April 27, 2007

**RE: SOURCE ZONE REMEDIATION PLAN ADDENDUM, FUEL LEAK CASE NO. RO0000278, DESERT PETROLEUM, 2008 1<sup>ST</sup> STREET, LIVERMORE, CALIFORNIA**

Golder Associates Inc. (Golder) has prepared this addendum to our Source Zone Remediation Plan<sup>1</sup> on behalf of Valley Gas (Formerly B&C Minimart) for the Dessert Petroleum (DP) site at 2008 1<sup>st</sup> Street, Livermore, California. This addendum has been prepared in response to and as requested by the Alameda County Environmental Health Services (ACEHS) in a letter dated March 26, 2007.<sup>2</sup> Pertinent excerpts of this ACEHS letter are included in Attachment A. Golder's responses to ACEHS's comments/requests, are in the following sections. The sections have been organized to correspond to the ACEHS letter.

**City of Livermore Utility Map**

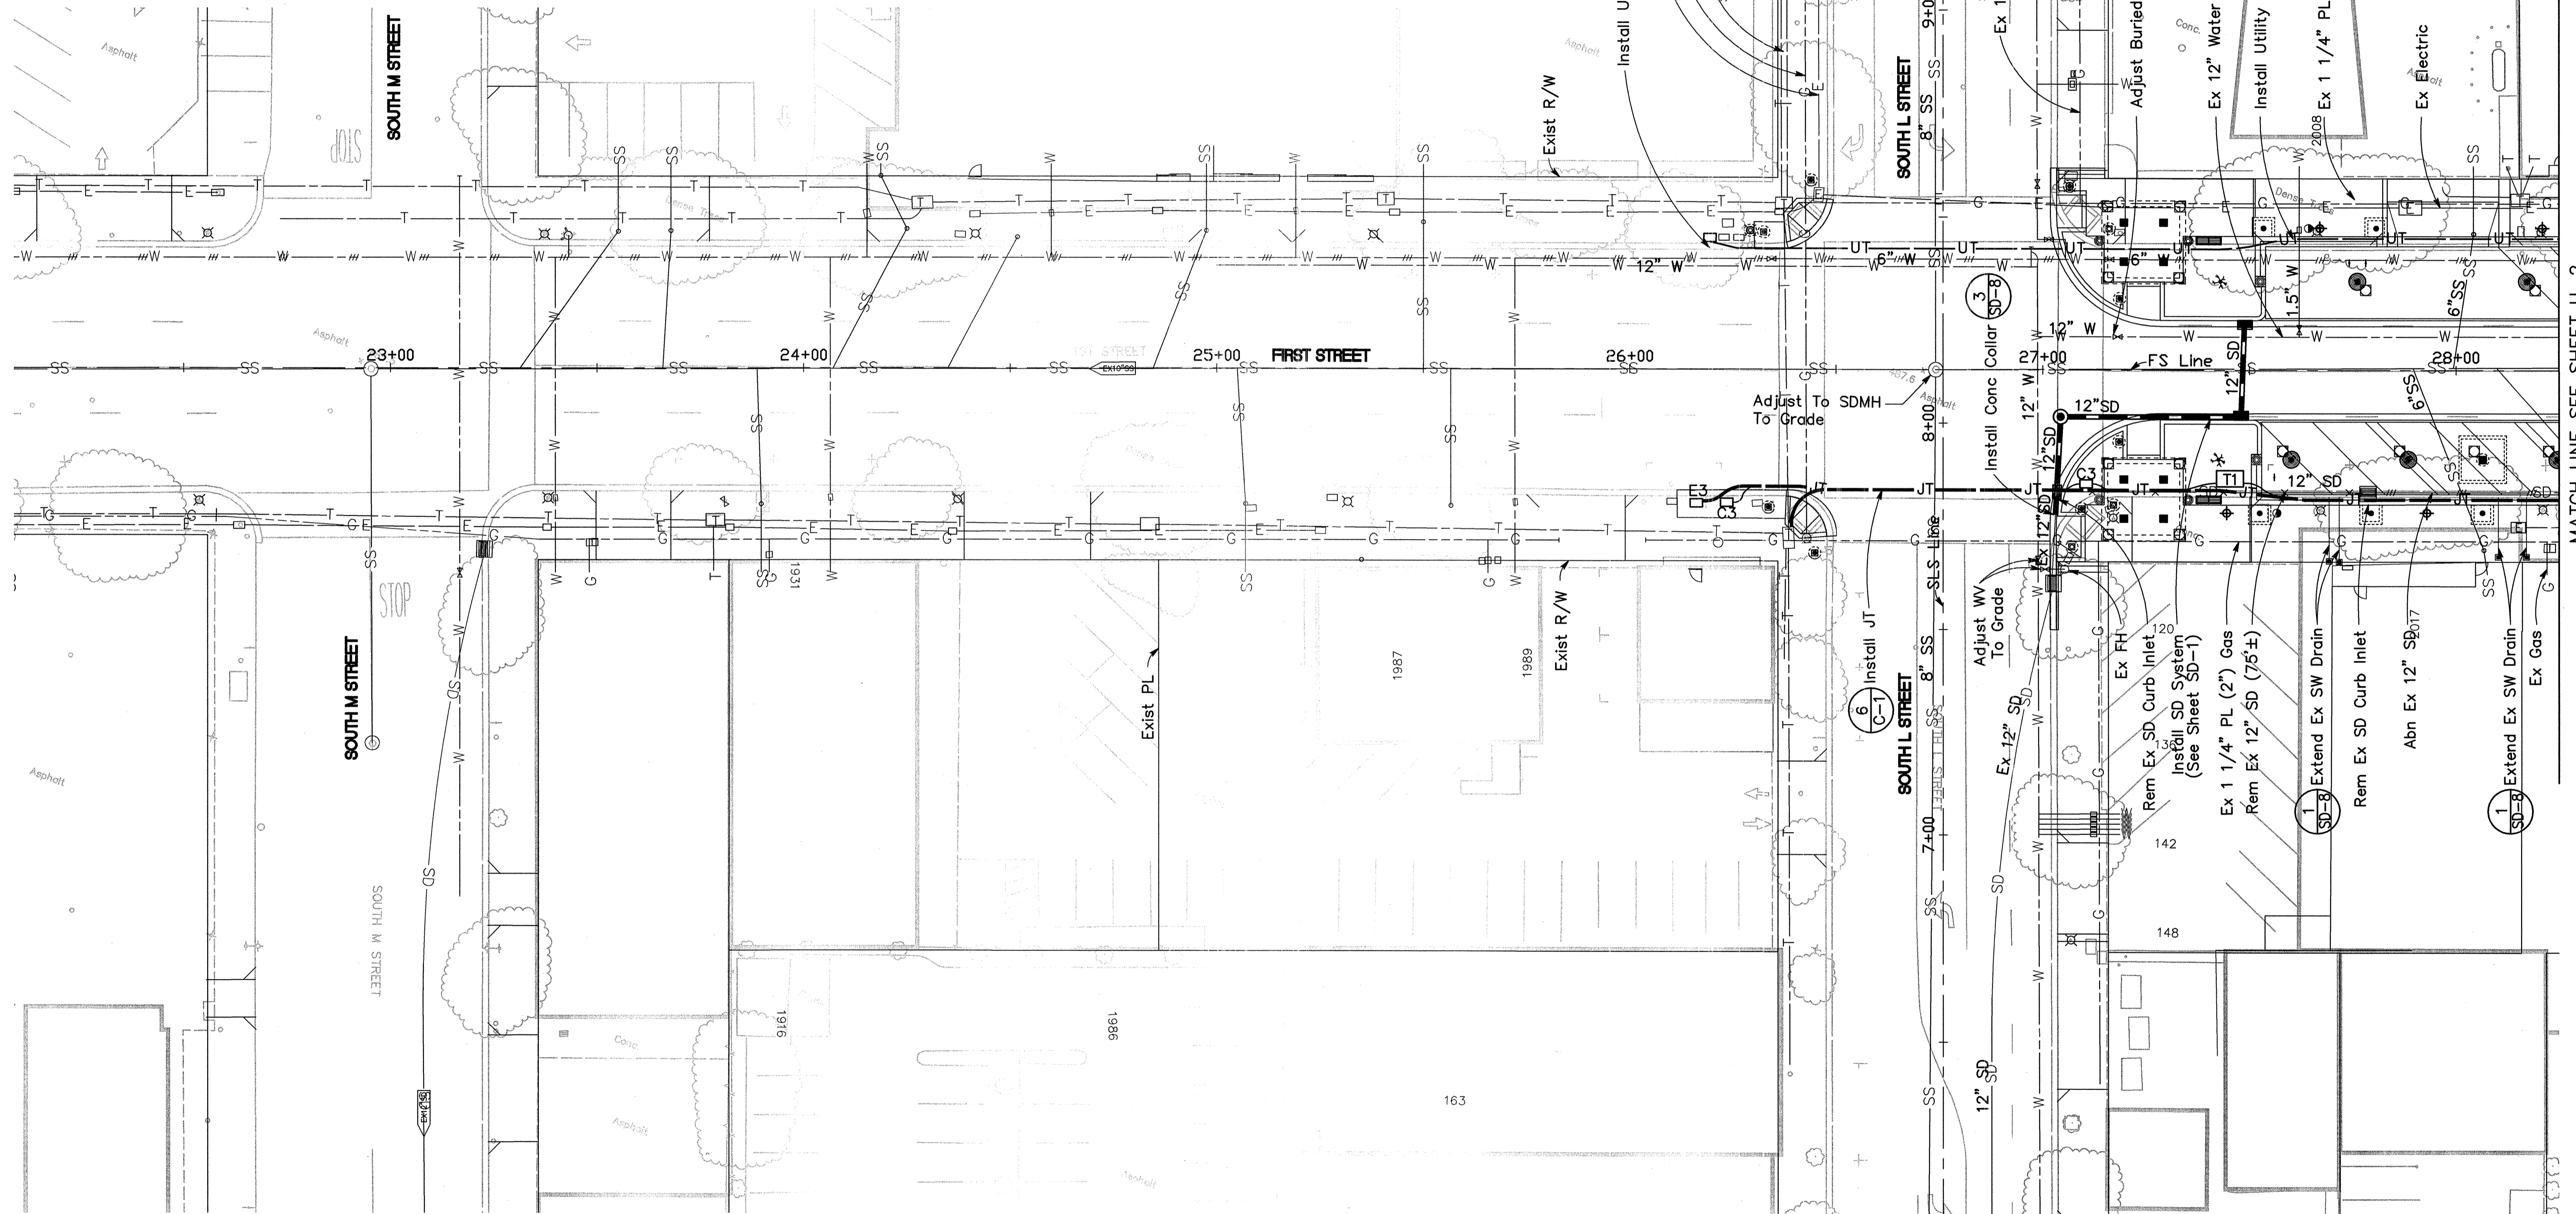
f. **Utility Survey** – The utility survey portion of your conduit study has not been completed, as noted in SCM 1.1 and the risk assessment. The presence of deep utilities and a potential petroleum pipeline are reported to be in the vicinity of your site and the Groth site and could act as a preferential pathway for contamination, oxidant and/or by-products of the reaction. We request that you complete your evaluation of this data gap for your pilot test proposal.

Golder acquired a utility map for the site vicinity and this is included in Attachment B. Golder will attempt to acquire information regarding the potential petroleum pipeline reported to be in the vicinity of the site and the Groth Brothers site. This information will be discussed in the pilot study report.
